Virginia Department of Environmental Quality's investigation into the Mountain Valley Watch report titled "Mountain Valley Pipeline Stabilization, Franklin County, VA"

## April 15, 2021

Photo 4. MBP photo showing blankets and matting providing temporary soil stabilization.

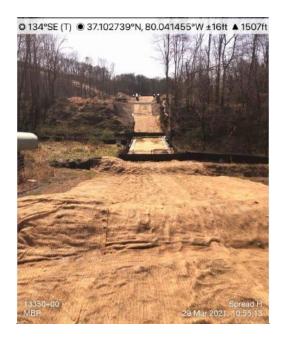
No exception is taken to MVW's observations that many areas are sparsely vegetated and the temporary stabilization needs maintenance. The aerial photographs were taken by MVW in January, when much of the vegetation stabilizing the right-of-way (ROW) is at the end of its effective life. The MVW report incorrectly stated that Minimum Standard 1, requires "the use of vegetation to stabilize soil and prevent erosion during and after land-disturbing activities". This implies that because the MVP ROW is not stabilized with vegetation, the project is not in compliance with the ESC Regulation. As the MVW report correctly notes, Minimum Standard 1 of the ESC regulation addresses soil stabilization. It does not specify that stabilization must be provided by vegetation. Because establishing and maintaining vegetation is not always possible on construction sites due to staging or seasonal constraints, other methods of stabilization may be applied. MVP has several approved alternative methods of soil stabilization, which it employs when vegetative stabilization is not successful or feasible. Although not always evident in the aerial photographs, soil stabilization has been maintained by MVP throughout the course of the project, per the requirements of Minimum Standard 1 and verified by DEQ field inspectors, through the application of straw, blankets and matting or soil stabilization pellets as exhibited in

Photos 3 & 4 of this report. When alternative methods of stabilization are used, and there may not be a highly visible ground cover, close inspection of the soil is necessary to verify that rill erosion and sediment transport is not occurring.

Photo 6. MVP photo showing hydraulic application of seed.

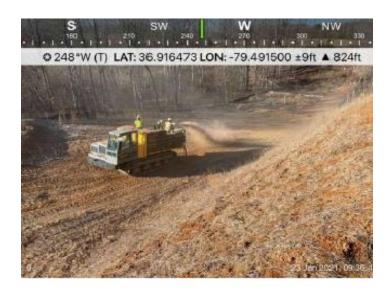
The first paragraph of the MVW report states, "No construction activity was observed during January and February, including maintenance of erosion control devices and seeding of ROW." While it may be true that no activity was observed by MVW, the implication that no activity including maintenance, took place during January and February of this year is not correct. All across the length of the project in Franklin County, reseeding and stabilization of ROW began in January and has continued through March. (Photos 6. & 7.) During those months since the MVW aerial photos were taken, the entire right-of way has been inspected, reseeded, and restabilized where needed. At this time, the primary request made in the MVW report - to inspect the ROW in Franklin County for sparse vegetation and re-seed as necessary – has already been carried out. The discussion which follows addresses specific issues beyond stabilization which are alleged in the captions accompanying the MVW photographs
